NED-84-304

NRC DOCKETS 50-321, 50-366
OPERATING LICENSES DPR-57, NPF-5
EDWIN I. HATCH NUCLEAR PLANT UNITS 1, 2
RESPONSE TO REQUEST FOR INFORMATION ON
SAFETY PARAMETER DISPLAY SYSTEM

In response to your letter dated April 23, 1984, Georgia Power Company (GPC) provides herein information related to installation of the Safety Parameter Display System (SPDS) at Plant Hatch. Your questions are restated, followed by the GPC response.

Figure 22
Seismic Test Setup
2A0-VAI Voltage-to-Current Converter

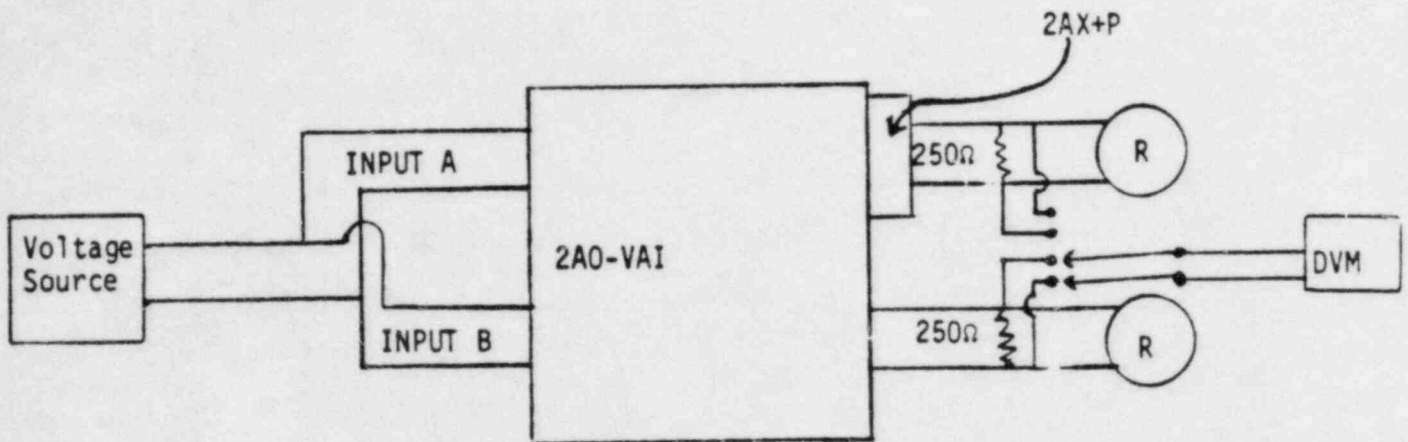
2.3.a For each type of device used to accomplish electrical isolation at Hatch 1 and 2, describe the specific testing performed to demonstrate that the device is acceptable for its applications(s). This description should include elementary diagrams where necessary to indicate the test configuration and how the maximum credible faults were applied to the devices."

Q0AAB44. Refer to Paragraph 5.4.2 and Figures 22, 31, 76, and 77 of attachment 1.
